METROPOLITAN GOVERNMENT OF NASHVILLE AND DAVIDSON COUNTY

STAFF RECOMMENDATION
3700 Richland Avenue
July 17, 2019

Application: New Construction—Addition; Setback determination
District: Richland-West End Neighborhood Conservation Zoning Overlay
Council District: 24
Base Zoning: RS7.5
Map and Parcel Number: 10409006000
Applicant: Steve Durden
Project Lead: Melissa Baldock, melissa.baldock@nashville.gov

Figure 4 (left) is the 1957 Sanborn Map, which shows that this area was formerly an attached garage. Figure 5 (right) is a 1996 photo that shows that the existing addition did not exist at that time.

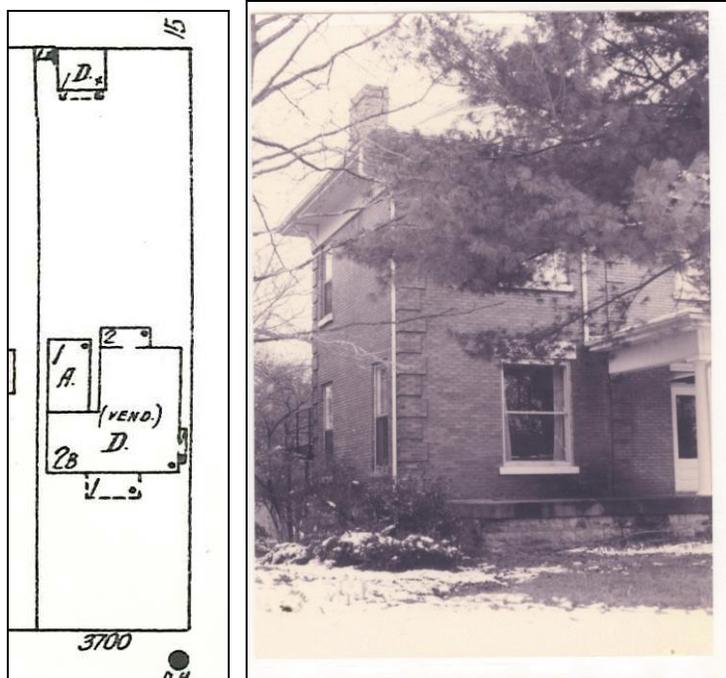
Partial Demolition: The new addition requires the removal of an existing addition on the left side of the rear of the house, which is not highly visible from the street (Figures 2 & 3). The date of construction of the addition is not known. The 1957 Sanborn maps

shows that this part of the house was formerly an attached garage (Figure 4). A photo dating from 1996 does not show the existing addition (Figure 5). Staff therefore finds that the existing addition is not an historic part of the house and does not contribute to the historic house's architectural significance and character. Staff therefore finds that its demolition meets Section III.B.2 for appropriate demolition and does not meet section III.B.1 for inappropriate demolition.
